SNUPPS

Standardized Nuclear Unit
Power Plant System

April 17, 1984

SLNRC 84-0069 FILE: 0278
SUBJ: Revision in Diesel Generator
Start Time

FIGURE 15.6-19
MASS VELOCITY
DECLG ($C_D=0.6$)

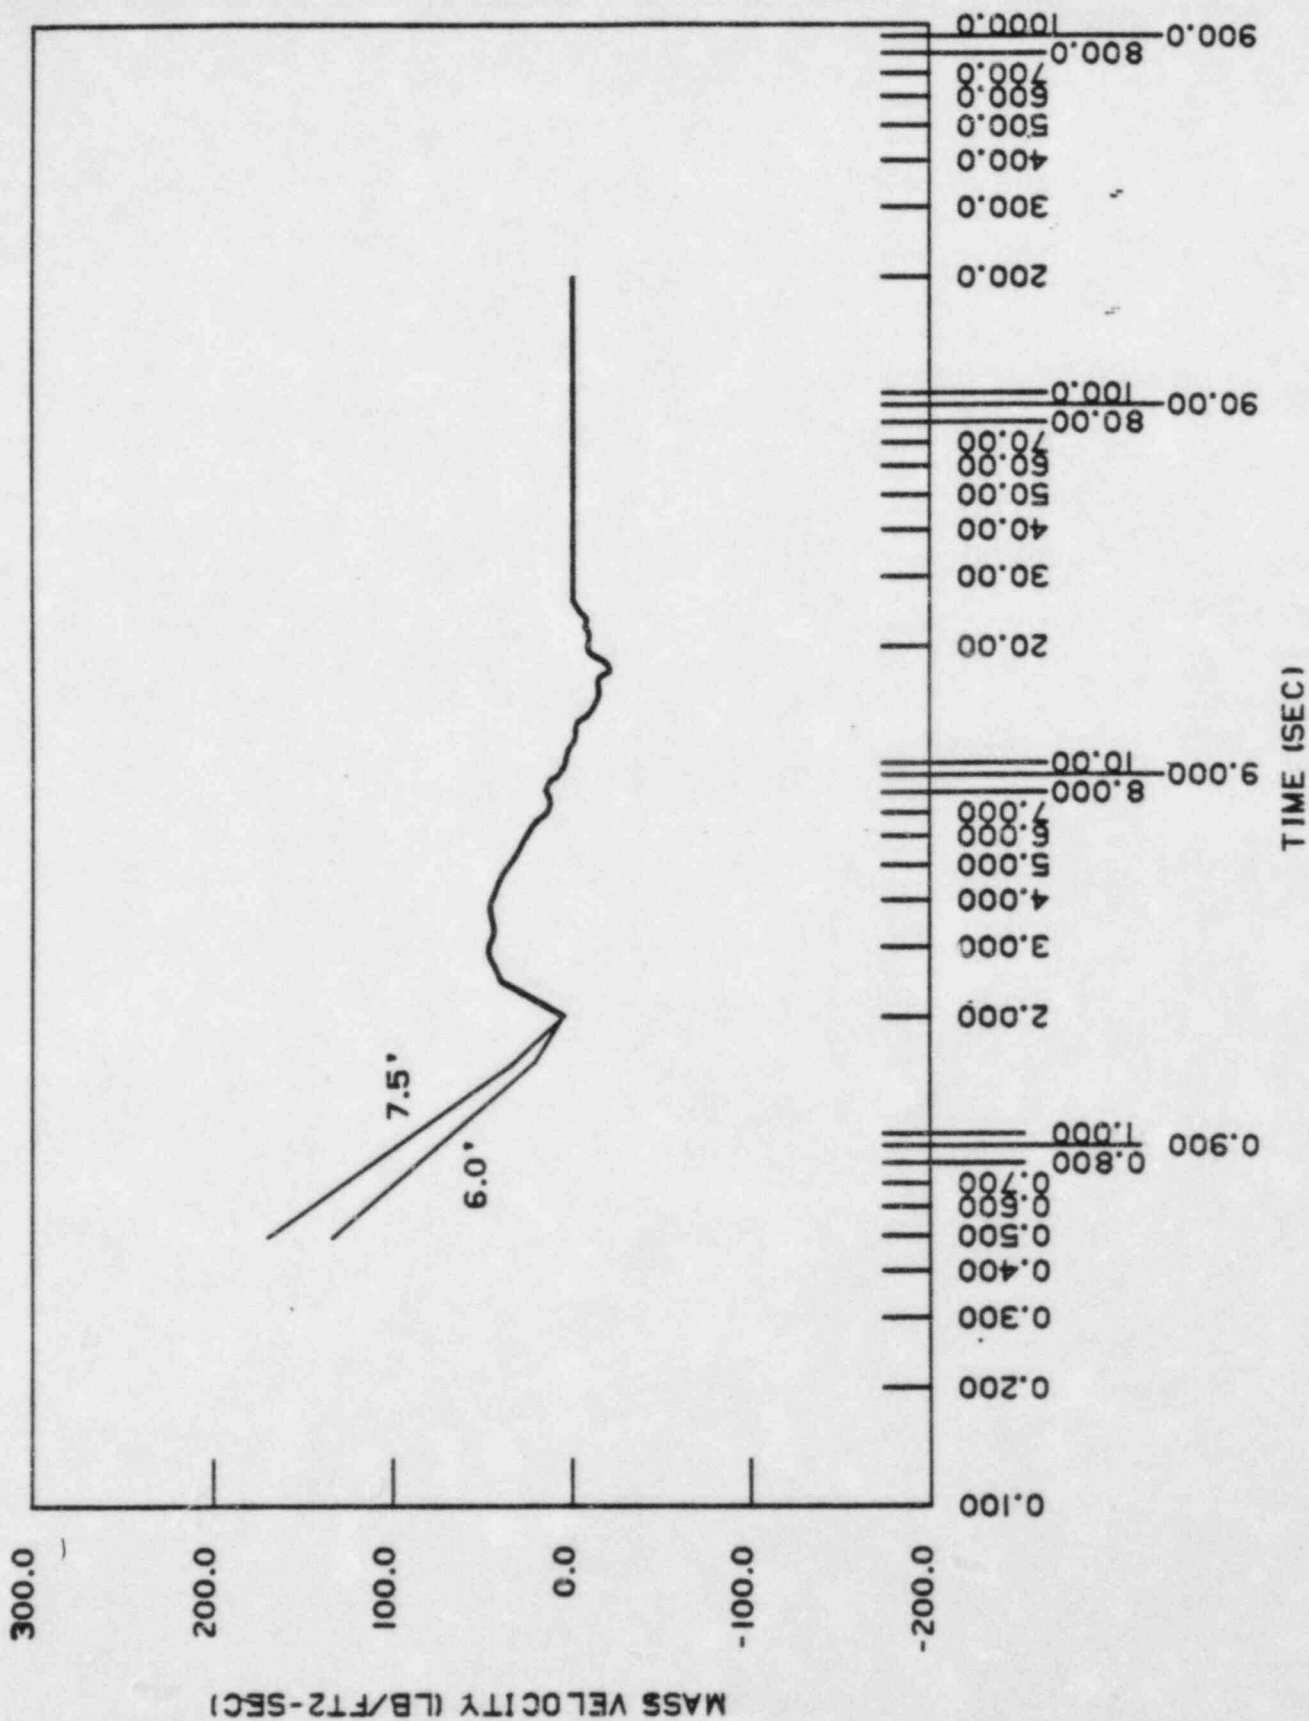
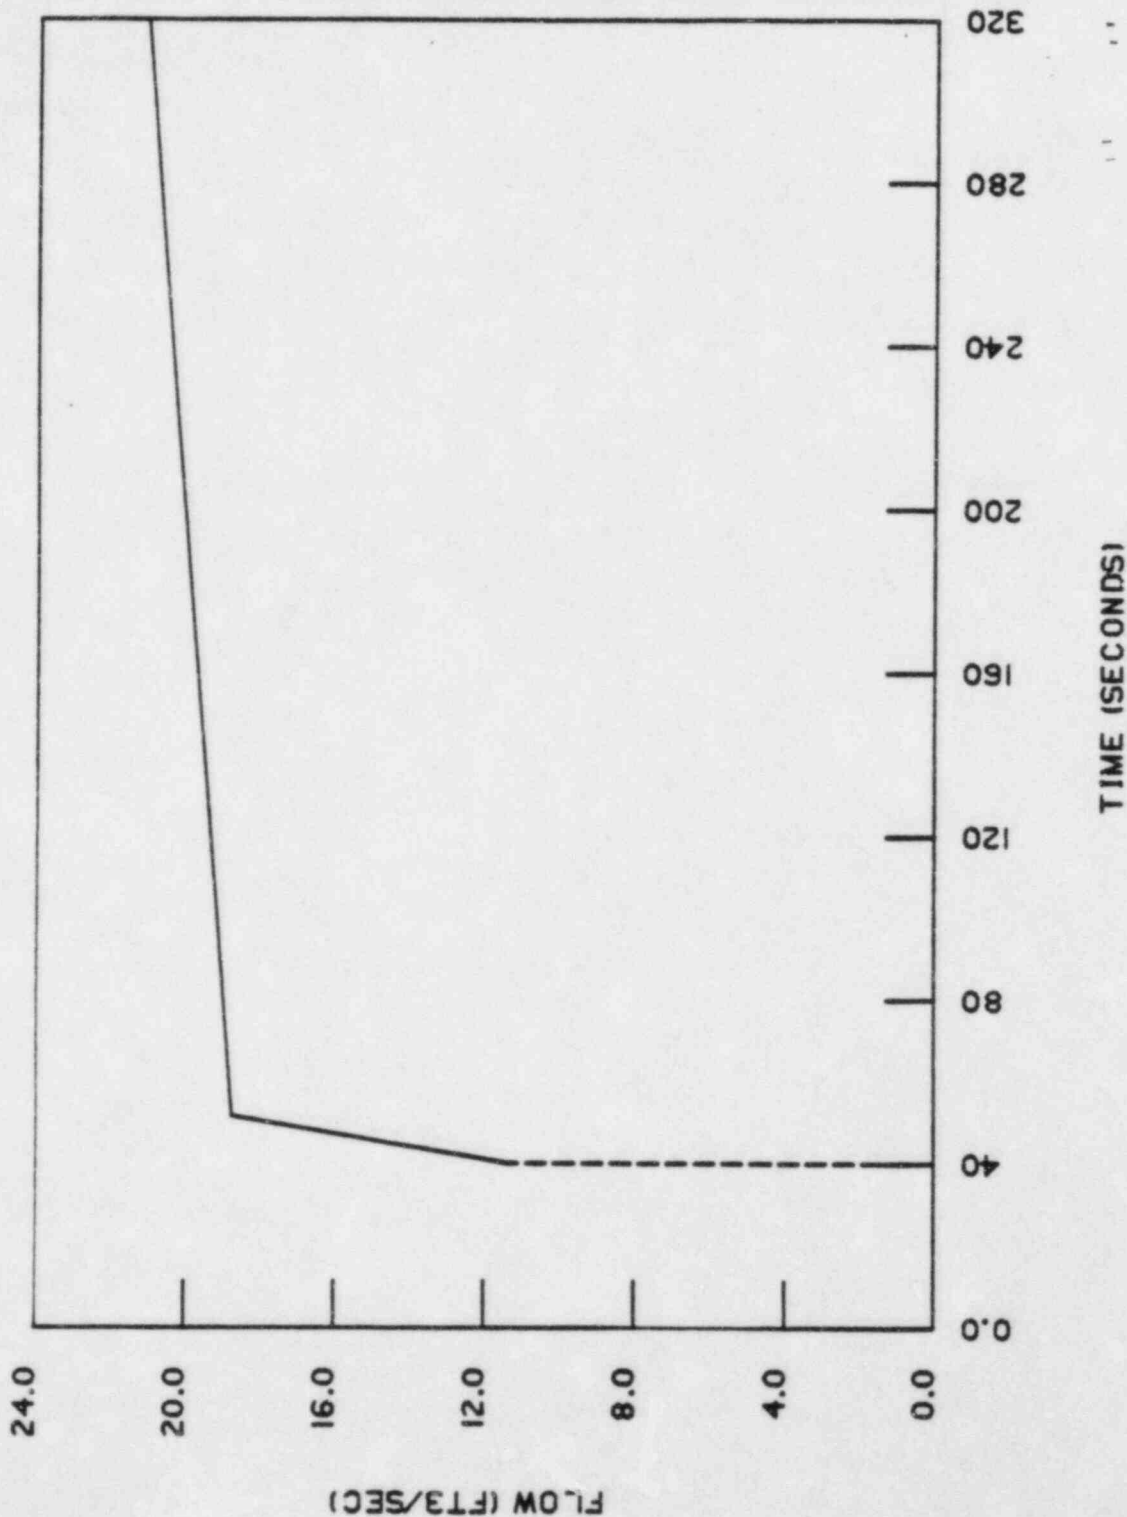
12 SEC
DIG START
